ADDENDUM NO. 3

February 25, 2022

DOUGLAS MACARTHUR ELEMENTARY SCHOOL ADDITIONS, RENOVATIONS, AND RELATED WORK

Crown Point, IN 46307

TD100

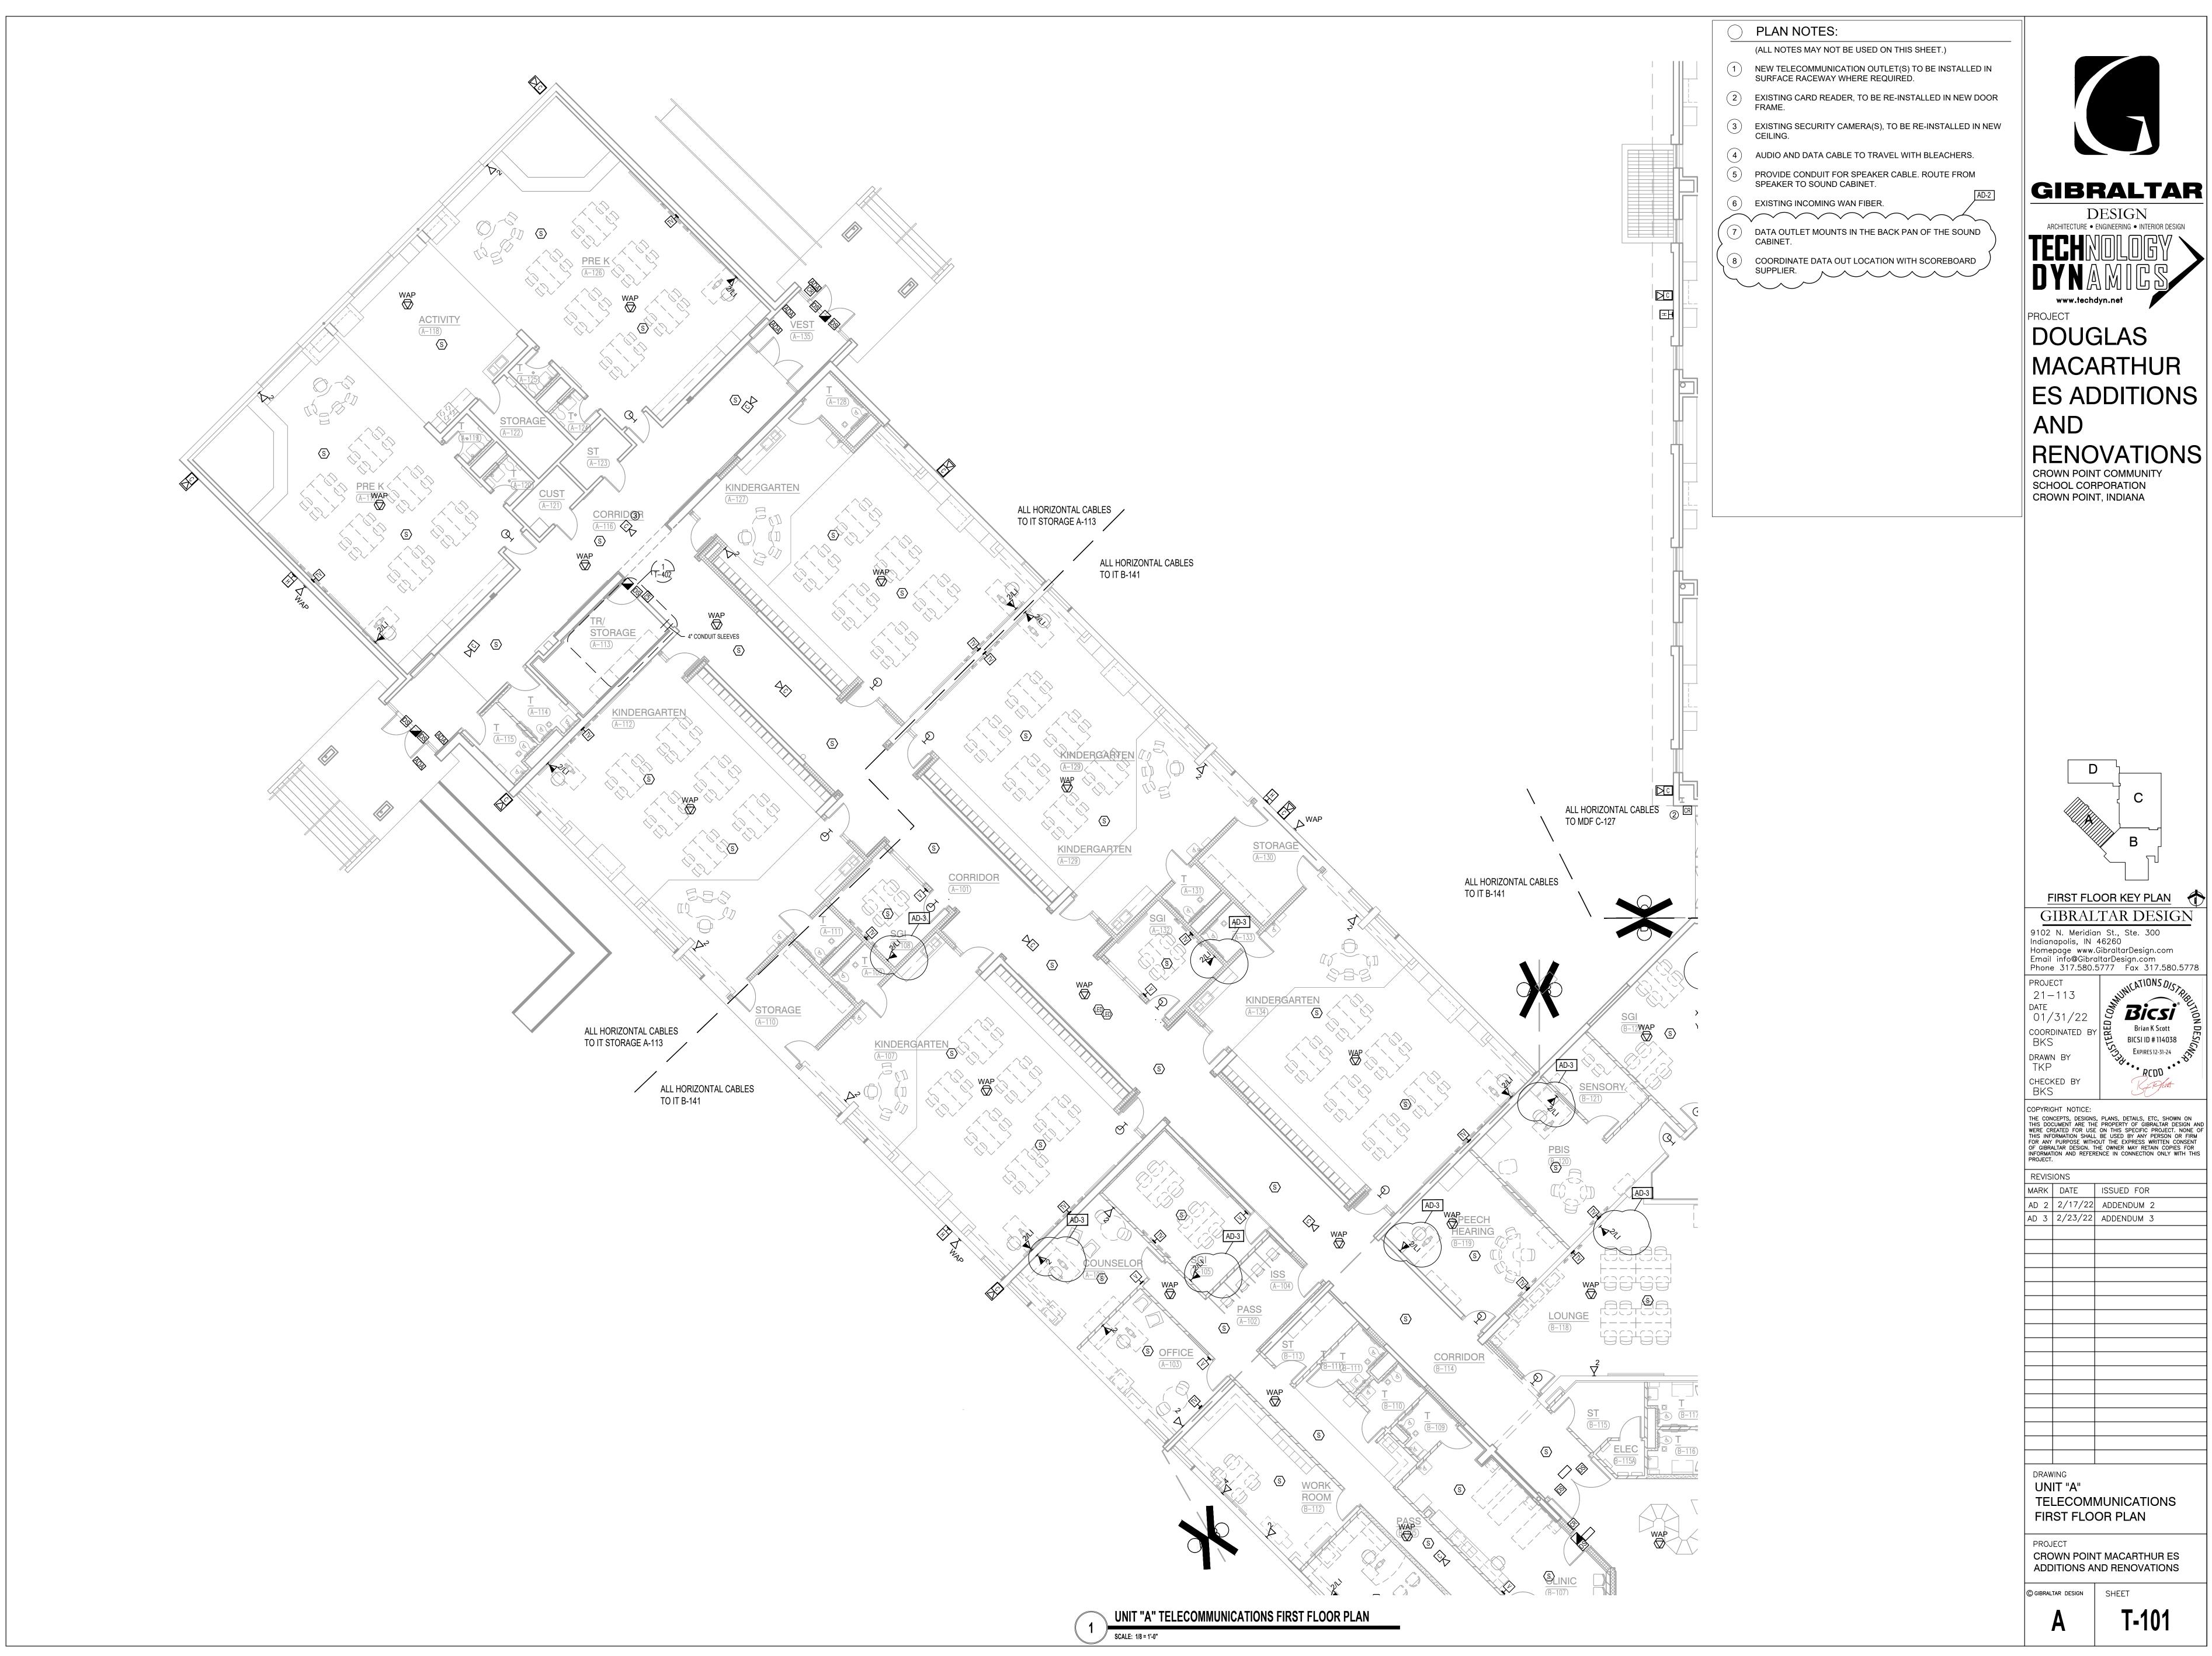
58. Sheet TD 100 (and all demo sheets)
